ROAD DESIGN MANUAL REVISIONS
January, 2016

CHAPTER 2G

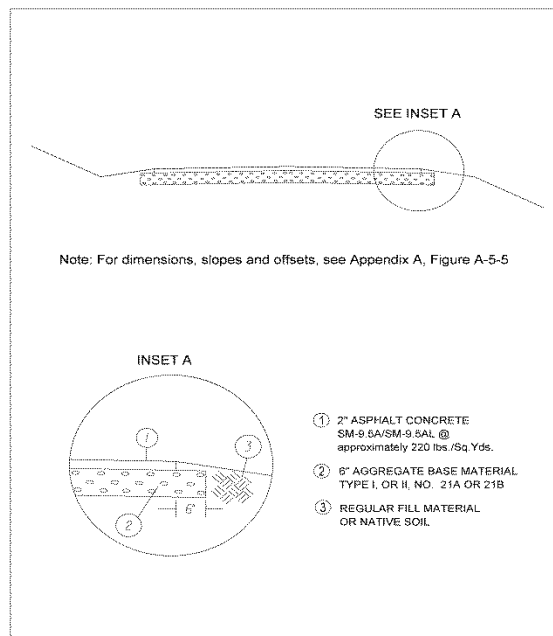
- Page 2G-19 – Revised the following language in the first paragraph under “ROADSIDE DEVELOPMENT” from; *“Quantities relative to Roadside Development and Temporary Erosion and Sediment Control are summarized on the Roadside Development Sheet provided as a CADD file. This is a multi-purpose sheet providing types of seed mixtures, rates of application, and quantities. Quantities relative to temporary Erosion and Siltation Control shall be summarized on the Roadside Development Sheet, with the exception of any necessary outfall pipe, which will be summarized in the drainage summary.”* To; *Quantities relative to Roadside Development and Temporary Erosion and Sediment Control are summarized on the “appropriate” sheet provided as a CADD file.*

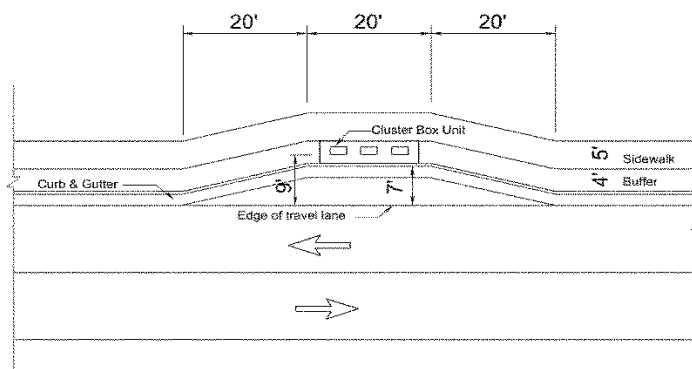
- Page B-45 – Revised the following language in the first sentence under item #7 Curb Extension to add “(Bulb-Outs)”

Added the following language to “FIGURE 15 – CURB EXTENSION DETAIL” to “FIGURE 15 – CURB EXTENSION “(BULB OUTS)” DETAIL”.

Detail for Cluster Box Unit Turnout

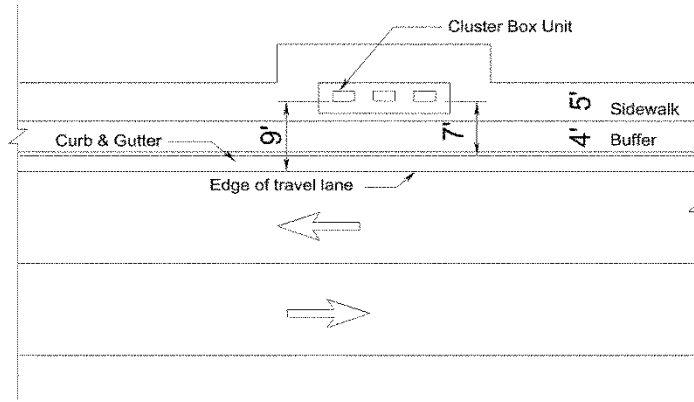
- Page B(1)-41 & 42 – Added the following language;
“Units (CBUs) may be required by the U.S. Postal Service in subdivisions. If so, the placement of CBUs will be restricted to subdivision streets with design speeds of 30 mph or less and shall be located outside the clear zone (7 feet minimum measured from the face of curb or 9 feet minimum from the edge of travel lane on a shoulder and ditch typical section).

Contact your local USPS representative for USPS Approved Specifications for the Concrete Pad for Single or Multiple Units as well as the CBU orientation (access for USPS delivery and customer) relative to the roadway. CBUs shall be ADA accessible in accordance with IIM-LD-55 (Curb Ramps and Sidewalks). See Details for CBU Turnout and CBU Without Turnout below.”
